**AMENDMENTS TO THE DRAWINGS:**

**REMARKS**

Applicant agrees with the suggestion to adopt a more descriptive title. Applicant proposes "WIND POWER PLANT HAVING MAGNETIC FIELD ADJUSTMENT ACCORDING TO ROTATION SPEED" as being properly descriptive. Approval of the new title is respectfully requested.

Fig 3

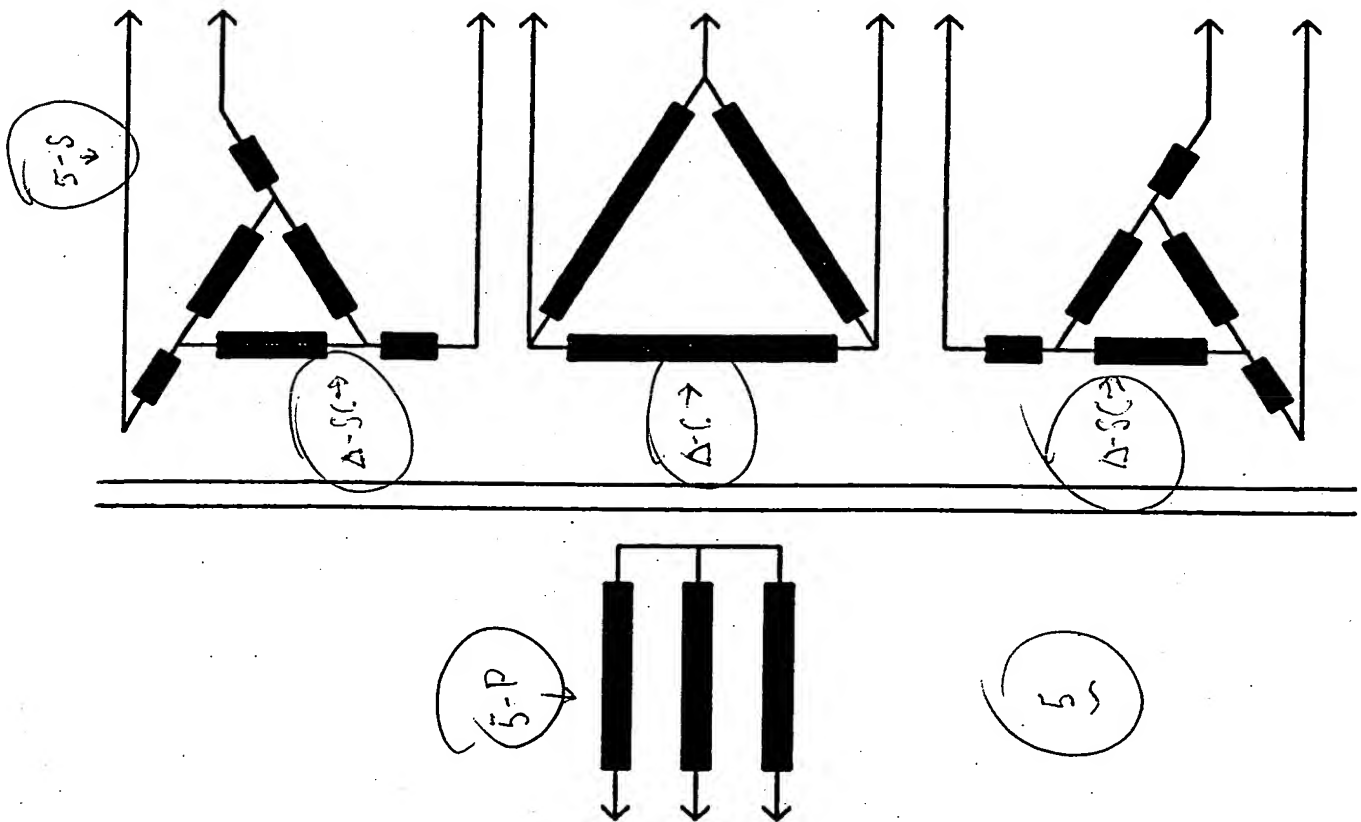
The attached sheet of drawings includes amendments to Figs. 3 and 4. These sheets replace the original sheets containing Figs. 3 and 4. In Figs. 3 and 4, previously omitted reference characters have been added.

The objection to Figs. 3 and 4 is overcome by amendment of those figures to contain labels identifying the shown parts of the claimed invention and their structural relationships.
